Review Date: **APRIL 4, 2023**

DO Permit No.: **PZ22-081**

Project Name: **PROPOSED COMMERCIAL RENOVATION – LA BRISA INN**
5711 EAST HIGHWAY 98, PARKER FLORIDA
SUBMITTAL NO. 5 REVIEW COMMENTS

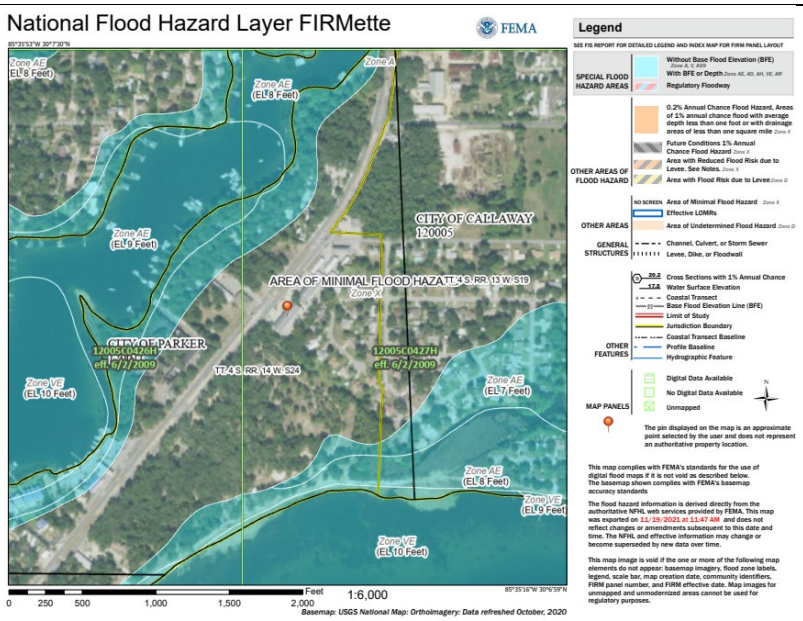
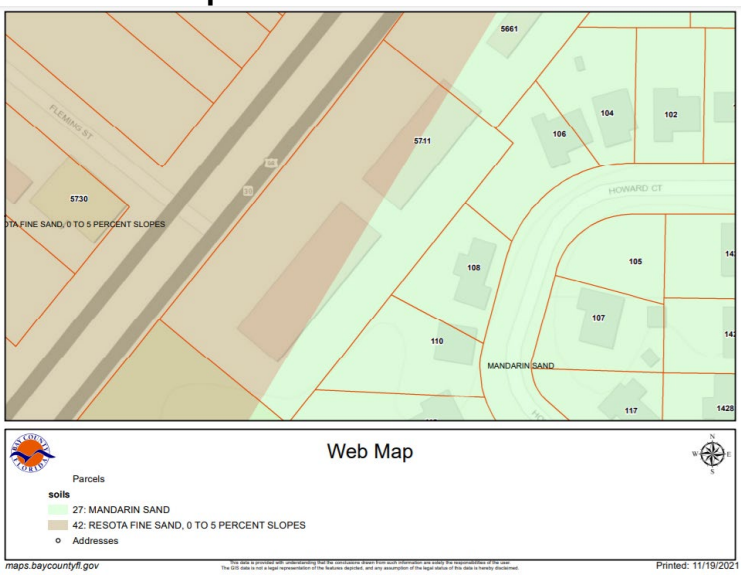
City Comment No. 10 from 04/03/2023 Review of Submittal No. 5
Applicant has provided a Landscape Plan which depicts sweet viburnum (shrubs) to be planted on the rear property line which is adjacent to the low density residential that borders the property to the south. Centipede Sod (8,500 Square Feet) will be also placed near within the rear property line. Applicant has depicted two 2-foot diameter Natchez Crape Myrtle's in the northwest front boundary of the site, which will be used to enhance this area of Parker in accordance with Subarea 2 – Mixed Use Parkway (South Portion of East Highway 98).

A weather sensor irrigation system is proposed at the site which will have 57 heads at a pressure between 30 to 40 pounds per square inch (psi) to be directed to the shrubbery on the back boundary line and stormwater management system. It appears the Crape Myrtle's will be hand watered until they are established. ***Applicant has addressed this comment***.
